DEVELOPMENT NO.:	22005964
APPLICANT:	DEVELOPMENT HOLDINGS PTY. LTD.
ADDRESS:	58 CLIFF ST GLENELG EAST SA 5045
NATURE OF DEVELOPMENT:	Construction of a child care centre ('pre-school') with associated car parking, landscaping, advertisement displays and fencing
ZONING INFORMATION:	<p>Zones:</p> <ul style="list-style-type: none"> • General Neighbourhood <p>Overlays:</p> <ul style="list-style-type: none"> • Airport Building Heights (Regulated) • Affordable Housing • Building Near Airfields • Prescribed Wells Area • Regulated and Significant Tree • Stormwater Management • Urban Tree Canopy
LODGEMENT DATE:	28 Feb 2022
RELEVANT AUTHORITY:	Assessment Panel at City of Holdfast Bay
PLANNING & DESIGN CODE VERSION:	2022.3
CATEGORY OF DEVELOPMENT:	Code Assessed - Performance Assessed
NOTIFICATION:	Yes
RECOMMENDING OFFICER:	Michael Gates Development Services (Planning And Building) Lead
REFERRALS NON-STATUTORY:	Engineering

DETAILED DESCRIPTION OF PROPOSAL:

Signage

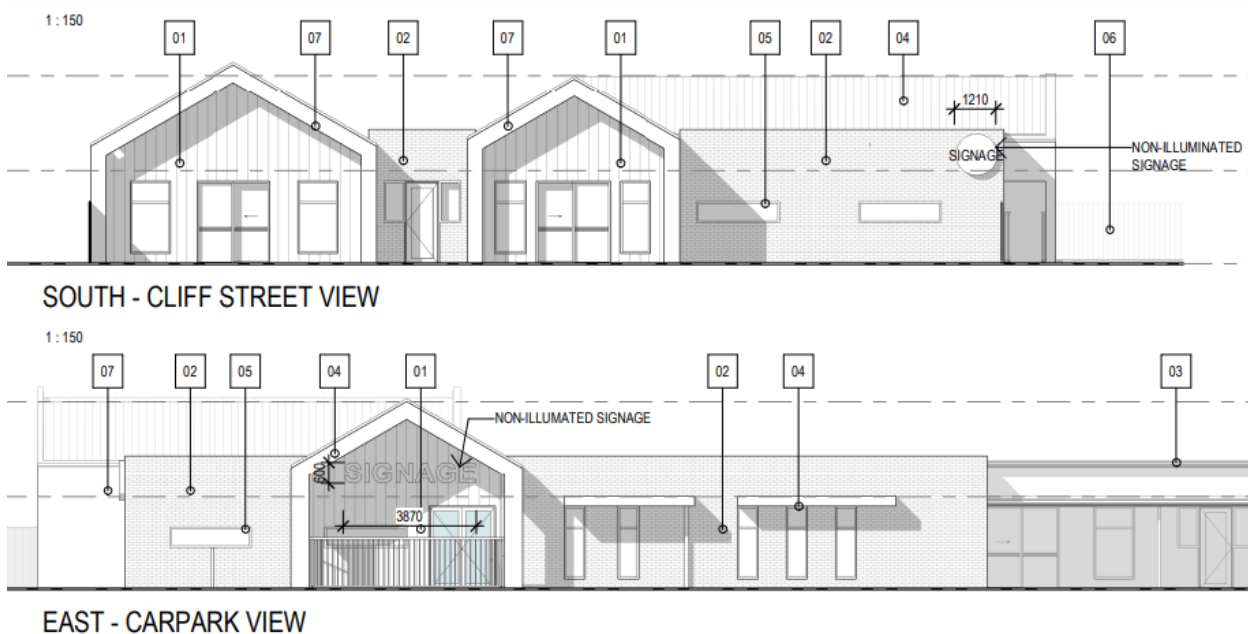
The signage associated with the development is of a relatively minor scale. There is a small circular sign proposed on the front façade, and a sign under a canopy facing the carpark. Both signs are not illuminated and are of a scale that is considered to not unreasonably impact on the amenity of the locality. The two signs are located on different facades of the building and therefore do not present a proliferation as required by the Planning and Design Code.
